Access Compliance Report

Public Rights-of-Way

Intersection ID: 7699	Main Street: MT_KISCO_DR	Cross Street: SQUIRREL_HILL_RD	Location: SE
ADA ID: 7D5468464FDE	Ramp Type: Perp	Initial Pass/Fail: Fail	Overall Compliance: No
Severity Score: 10			
Codes/Mitigation Info/Possible Solution		Field Measurements/Component Compliance

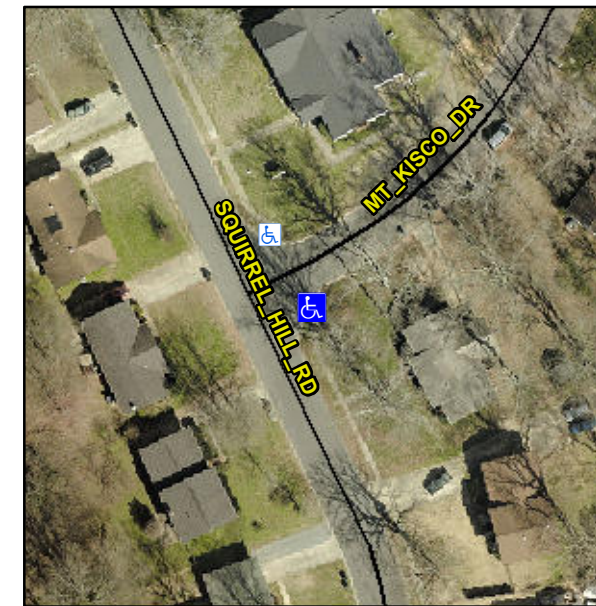
Not Found, R304.5.1, R304.5.3

Compliance	Description	Data	Compliance	Description	Data
N/A	Ramp Length (in)	47.0	Yes	Ramp Slope (%)	5.2
No	Ramp Width (in)	41.0	No	Ramp XSlope (%)	2.8
N/A	Flare Type LT	N/A	N/A	Flare Type RT	N/A
N/A	Flare Slope LT (%)	N/A	N/A	Flare Slope RT (%)	N/A
N/A	Flare Traversable LT?	N/A	N/A	Flare Traversable RT?	N/A
N/A	Landing Length (in)	N/A	N/A	DWS Provided?	N/A
N/A	Landing Width (in)	N/A	N/A	DWS Contrast?	N/A
N/A	Landing Slope (%)	N/A	N/A	DWS Length (in)	N/A
N/A	Landing X Slope (%)	N/A	N/A	DWS Full Width?	N/A
N/A	Landing Curb? (Y/N)	N/A	N/A	DWS Offset (in)	N/A
N/A	Shared Landing?	N/A			
N/A	Gutter Ponding?	N/A	N/A	Gutter Slope (%)	N/A
N/A	Gutter Lip Ht (in)	N/A	N/A	Gutter X Slope (%)	N/A
N/A	Painted X Walk1?	No	N/A	Painted X Walk2?	N/A
	X Walk 1 Direction	To N		X Walk 2 Direction	N/A
N/A	X Walk 1 Width (in)	N/A	N/A	X Walk 2 Width (in)	N/A
	X Walk 1 Slope (%)	2.5		X Walk 2 Slope (%)	N/A
	X Walk 1 X Slope (%)	1.8		X Walk 2 X Slope (%)	N/A

Remove & Replace Entire Ramp.
